SCHINDEWOLF GYM ADDITION  
KLEIN INDEPENDENT SCHOOL DISTRICT  
SPRING, TEXAS

39-25107-00  
JANUARY 17, 2025  
ADDENDUM 1

**ADDENDUM 001**

DLR Group Project No. 39-25107-00

30-25107-00  
CONSTRUCTION DETAILS (4 OF 4)  
**C11.3**

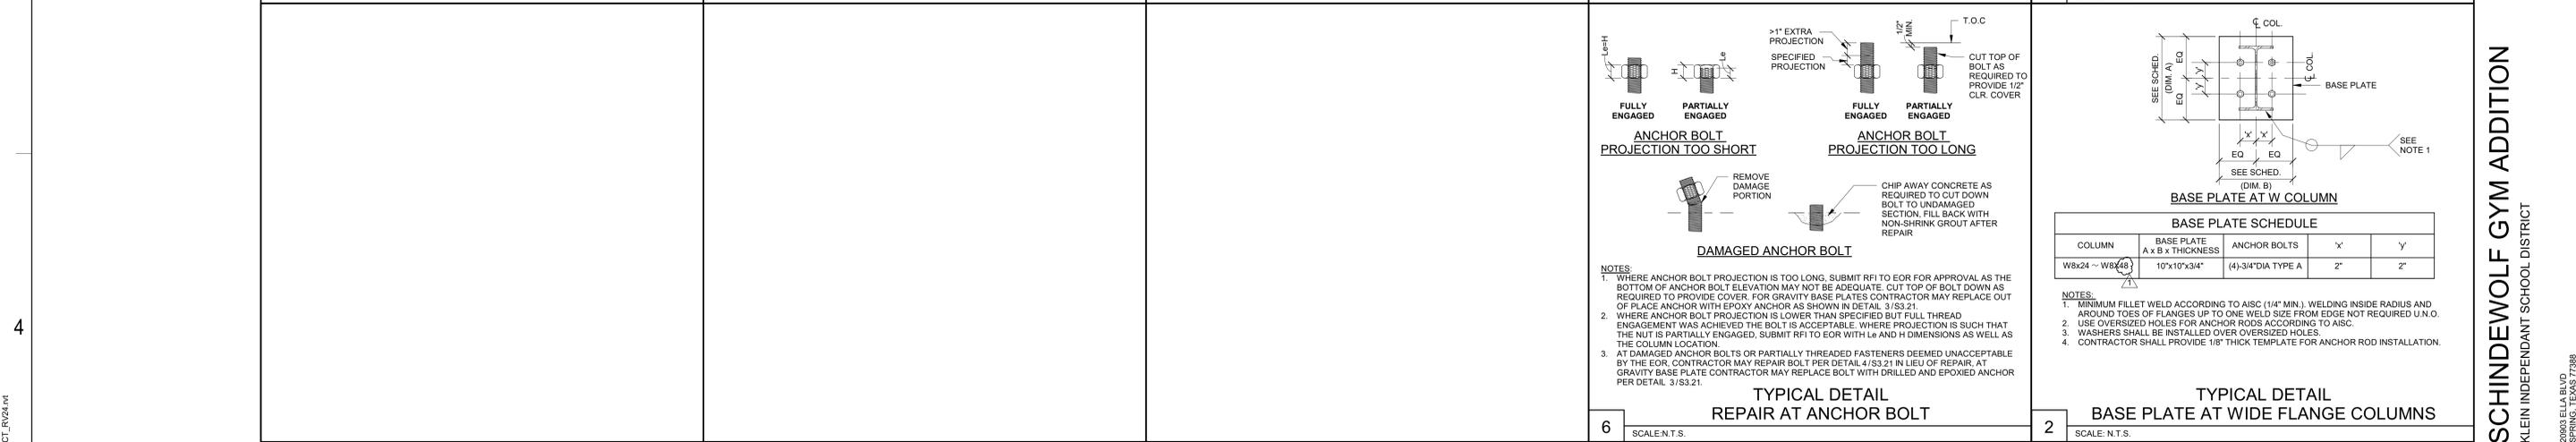
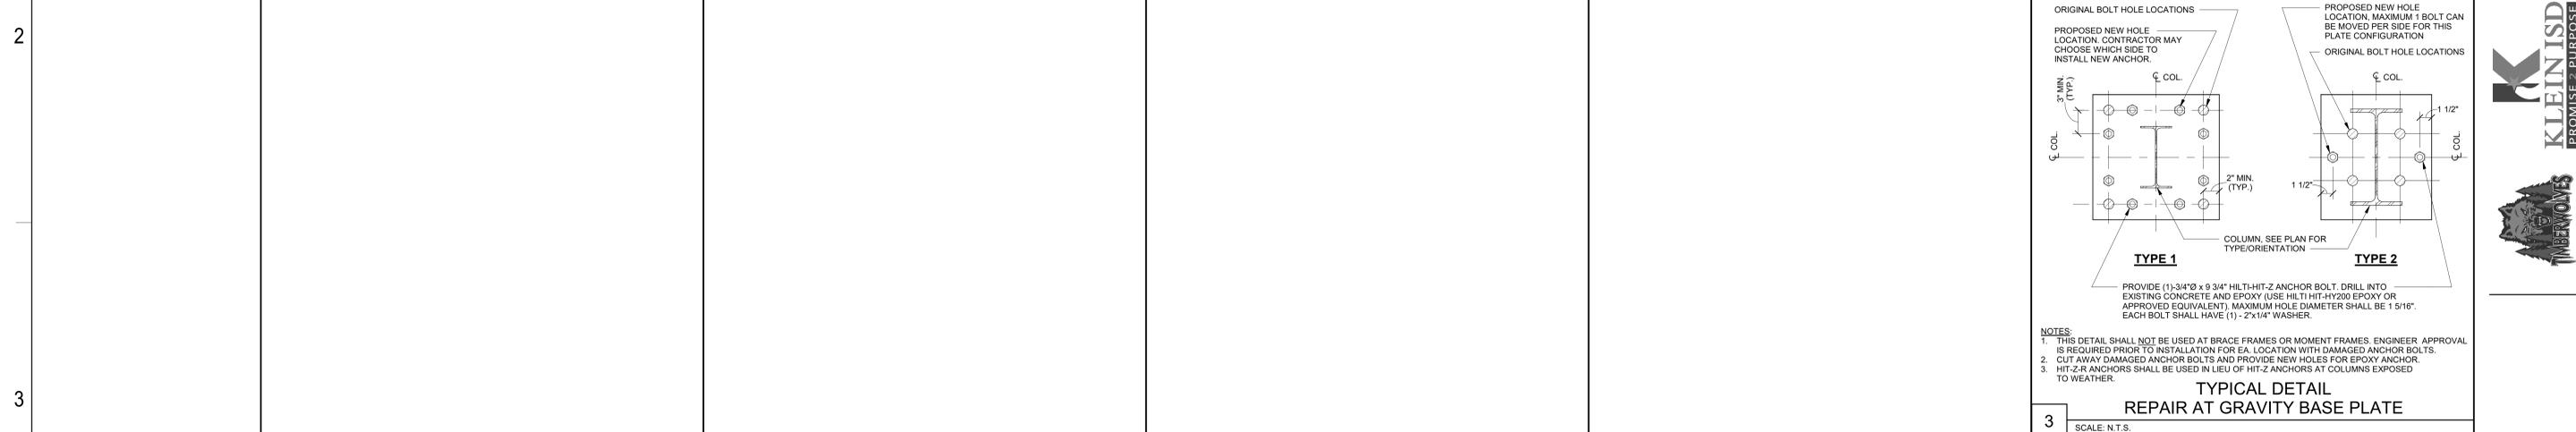
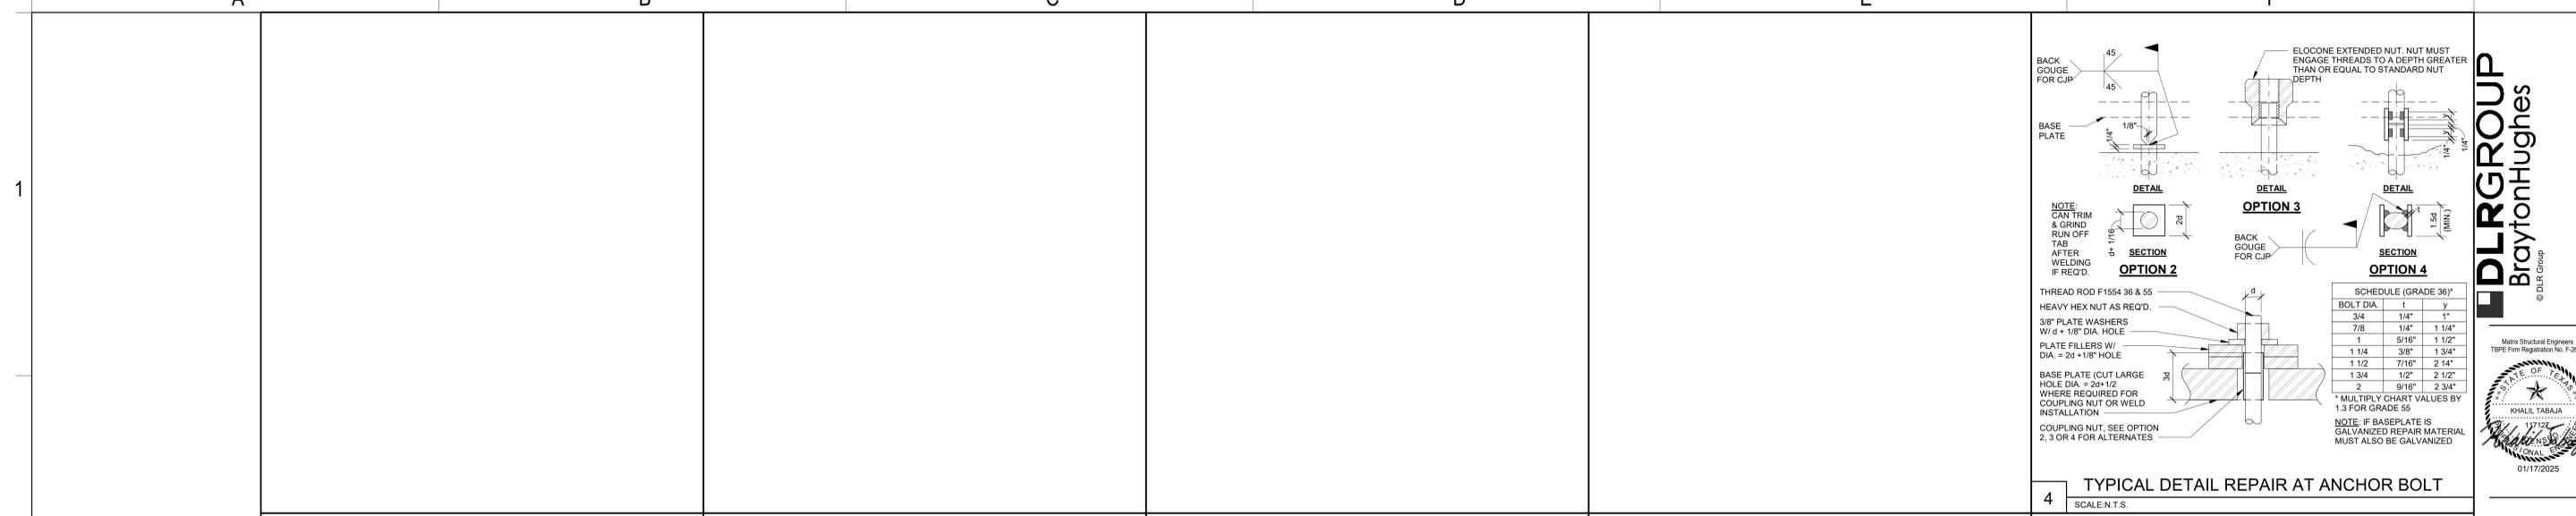
**ITEM NO. 9 - SHEET C11.3 - CONSTRUCTION DETAILS (4 OF 4)**

- a. Added sheet in its entirety.

**1 MECHANICAL PLAN LEVEL 1 - AREA A**  
1/8" = 1'-0"

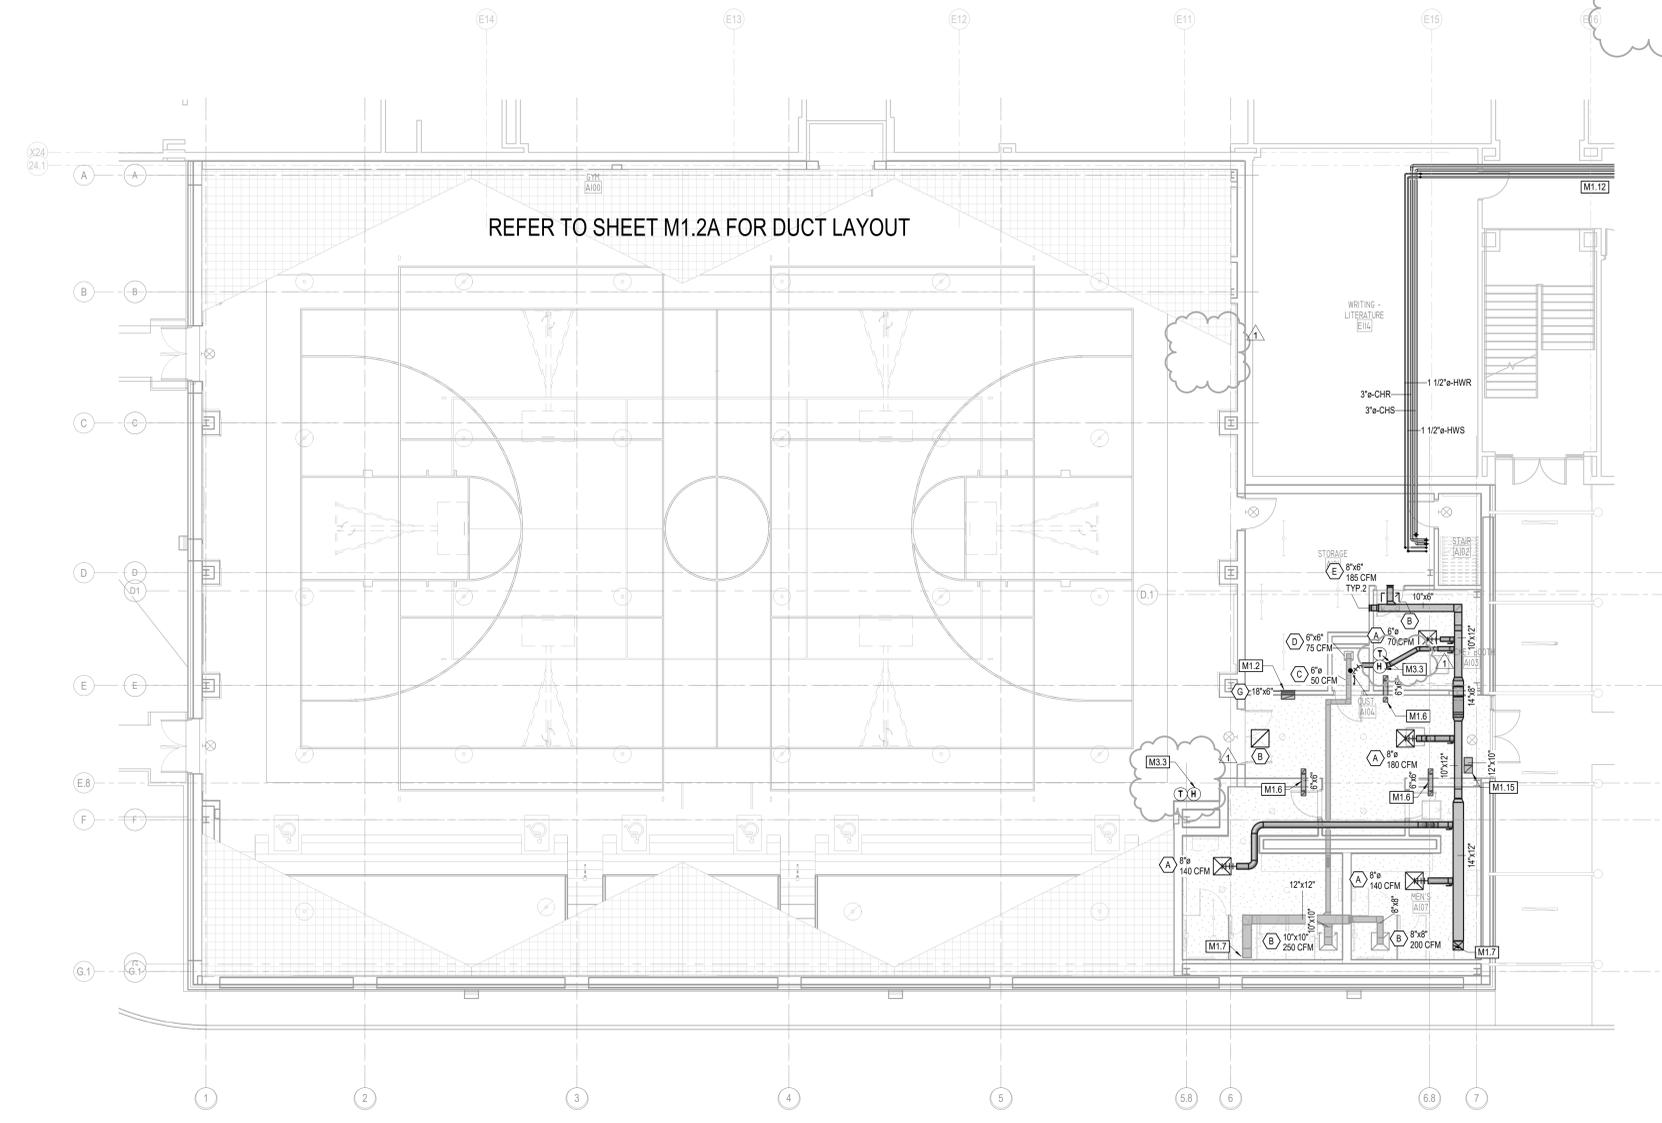
**ITEM NO. 13 - Sheet M1.1A - MECHANICAL PLAN LEVEL 1 - AREA A**

- a. Revised True North Arrow.
- b. Adjusted location of combination temperature / humidity sensor in the gym.
- c. Removed CO2 sensor in the gym and deleted corresponding M3.4 mechanical keyed note.
- d. Changed temperature sensor in Ticket Booth A103 to combination temperature / humidity sensor.
- e. Changed mechanical keyed note M3.4 to M3.3 in Ticket Booth A103.

**1 MEP SITE PLAN**  
1" = 20'-0"

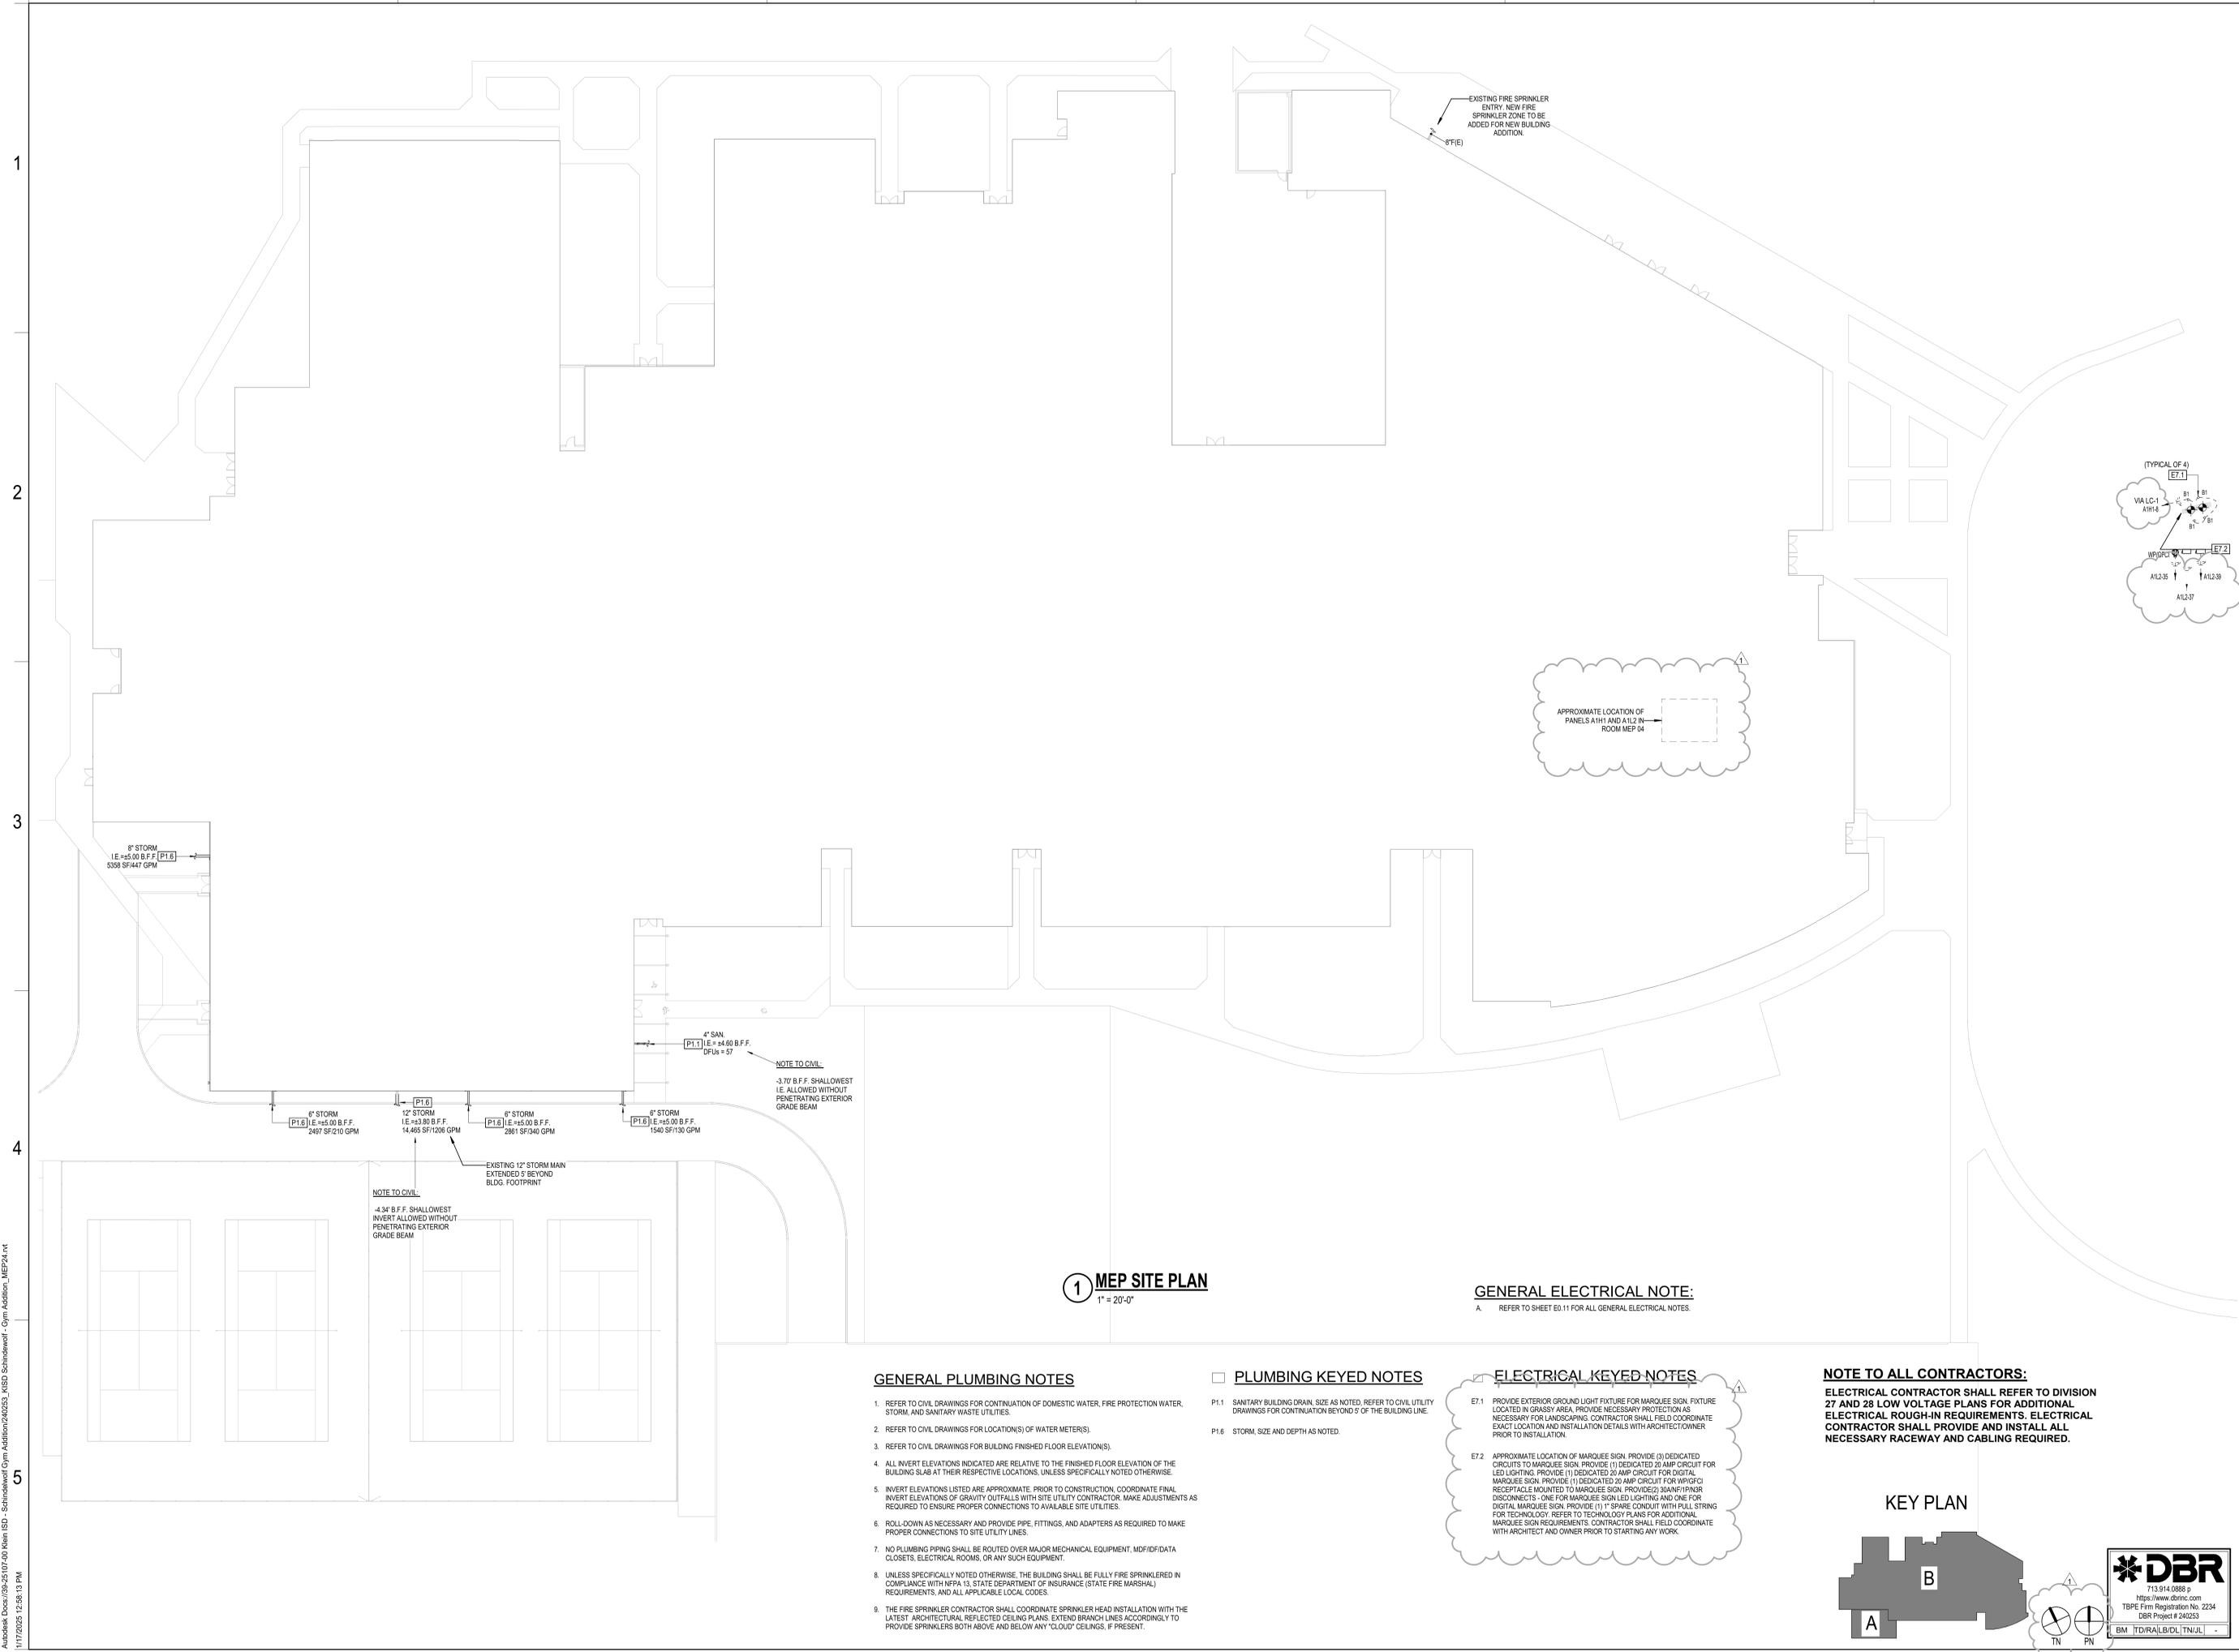
ITEM NO. 43 - Sheet MEP0.21 – MEP SITE PLAN

- a. Revised and removed details. See revised sheet.
- b. Revised electrical keyed notes. See revised sheet.
- c. Revised panel circuits for marquee sign. See revised sheet.
- d. Added approximate location of existing electrical room. See revised sheet.
